UNITED STATES PATENT AND TRADEMARK OFFICE

APPLICATION NO.	FILING DATE	FIRST NAMED INVENTOR	ATTORNEY DOCKET NO.	CONFIRMATION NO.
09/975,417	10/10/2001	Paul Swift	34580.001CC	9594

Office Action Summary

EXHIBIT

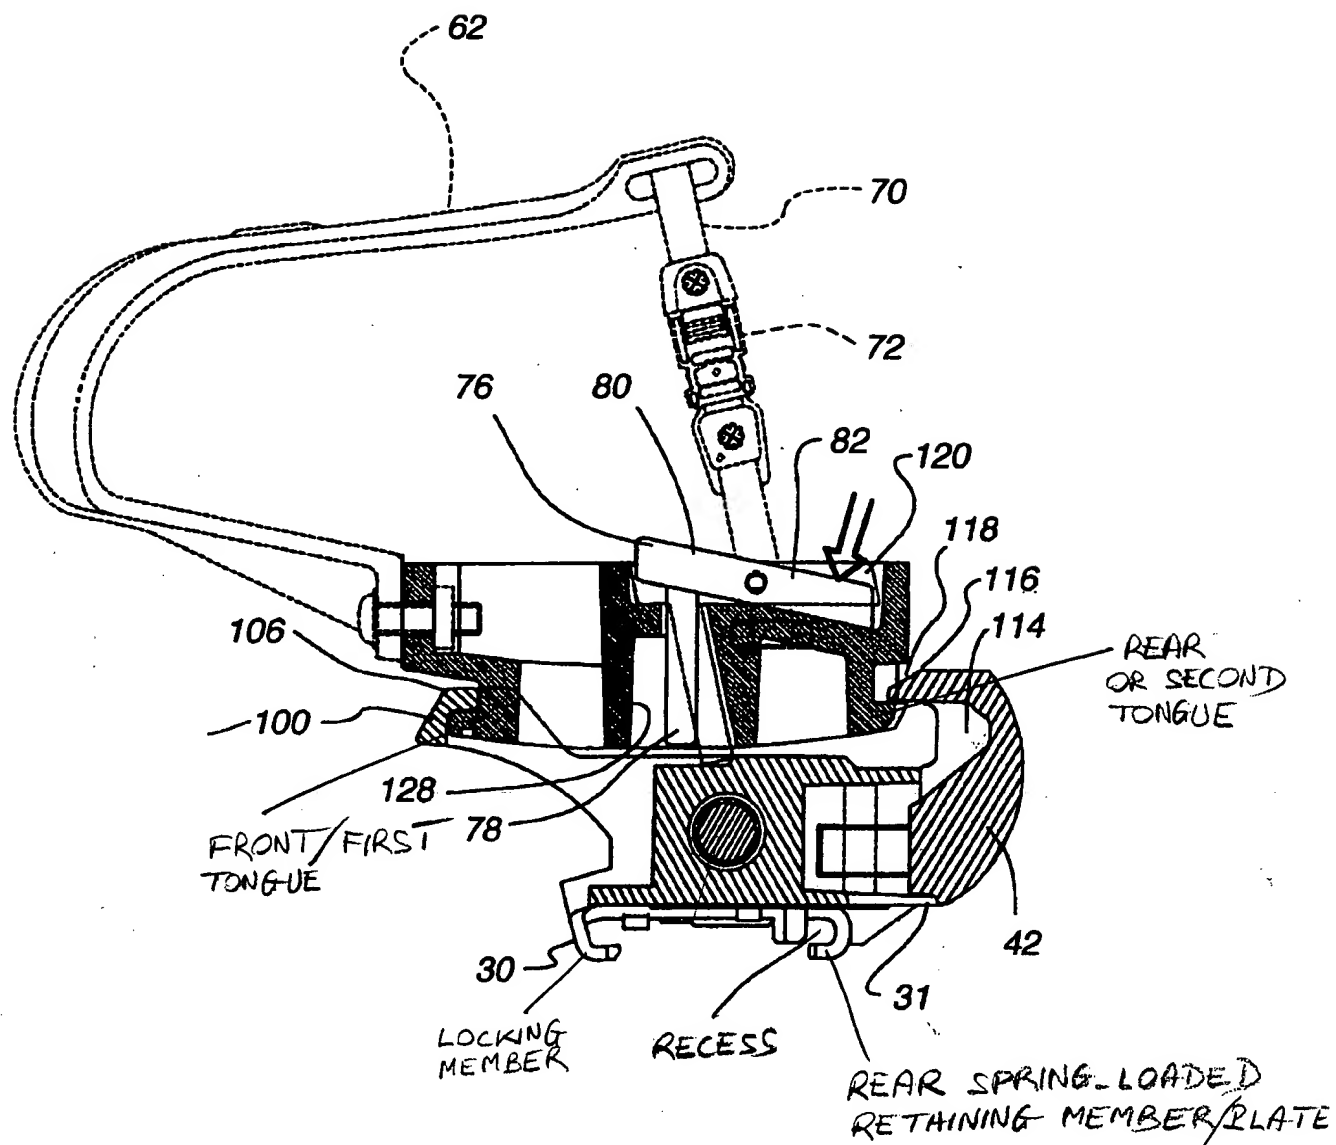
b. said top side 28 having a toe cleat clamp 26 which conforms to a bottom of a road type bicycle shoe cleat, the toe cleat clamp 26 having a front recess 100, 106 (Fig. 3) for receiving a front tongue (see attached Exhibit) of the road type bicycle shoe cleat 22 and a rear spring-loaded

b. said first side 28 conforming to a bottom of a bicycle road shoe cleat and having means 100, 106 (Fig. 3) for receiving a first tongue (see Exhibit) of the road shoe cleat 22 and a

c. said second side 31 conforming to a bottom of a mountain bicycle shoe cleat and having a locking member (see Exhibit) for receiving a first tongue of the mountain bicycle shoe cleat and a spring-loaded retaining member (see Exhibit) pivotable on said main body 24 such that a second tongue of the mountain bicycle shoe cleat is retained within the spring-loaded retaining member of said second side 31, where the spring-loaded retaining member of said second side 31 moves back into a locking position, and thereby locks the second tongue of the mountain bicycle shoe cleat thereto. *Ibid.*, lines 27-33, column 3. See also US Patent No. 5,692,415 which is incorporated into the disclosure of Gapinski.
